PIC16C72 Rev. A Silicon Errata Sheet

The PIC16C72 (Rev. A) parts you have received conform functionally to the Device Data Sheet (DS30390E), except for the anomalies described below.

FIGURE 1: SCK PULSE VARIATION USING TIMER2/2

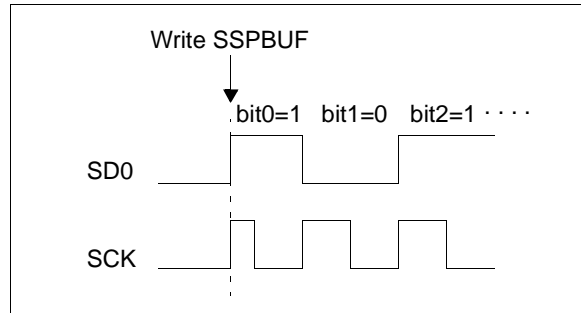
5. Module: SSP (SPI Mode)

When the SPI is using Timer2/2 as the clock source, a shorter than expected SCK pulse may occur on the first bit of the transmitted/received data (Figure 1).

To avoid producing the short pulse, turn off Timer2 and clear the TMR2 register, load the SSPBUF with the data to transmit, and then turn Timer2 back on. Refer to Example 1 for sample code.

FIGURE 1: WRITES TO TIMER1 (EXTERNAL CLOCK/OSCILLATOR MODE)

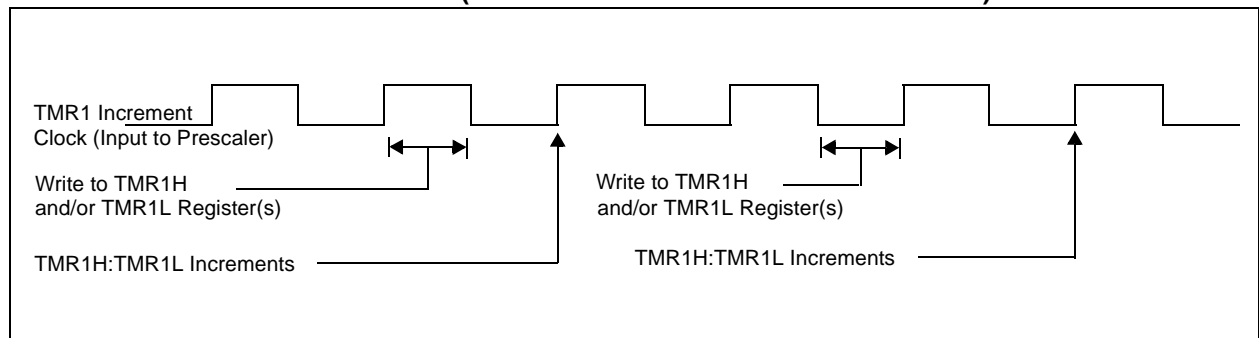
The operation of Timer1 needs some clarification when the timer registers are written when the TMR1ON bit is set.

The internal clock signal that is the input to the TMR1 prescaler affects the incrementing of Timer1 (TMR1H:TMR1L registers and the Timer1 prescaler). When the Timer1 registers are NOT written, the Timer1 will increment on the rising edge of the TMR1 increment clock.

When the TMR1H and/or TMR1L registers are written while this clock is high, TMR1 will increment on the next rising edge of this clock.

When the TMR1H and/or TMR1L registers are written while this clock is low, TMR1 will not increment on the next rising edge of this clock, but must first have a falling clock and the rising clock, for TMR1 to increment.

Figure 1 shows the two cases of writes to the TMR1H and/or TMR1L registers. Due to the V_{IH} and V_{IL} thresholds on the oscillator/clock pins, external Timer1 oscillator components, and external clock frequency, the Timer1 increment clock may not be of a 50% duty cycle.

The TMR1 increment clock is out of phase of the T1OSO/T1CKI pin by a small propagation delay.
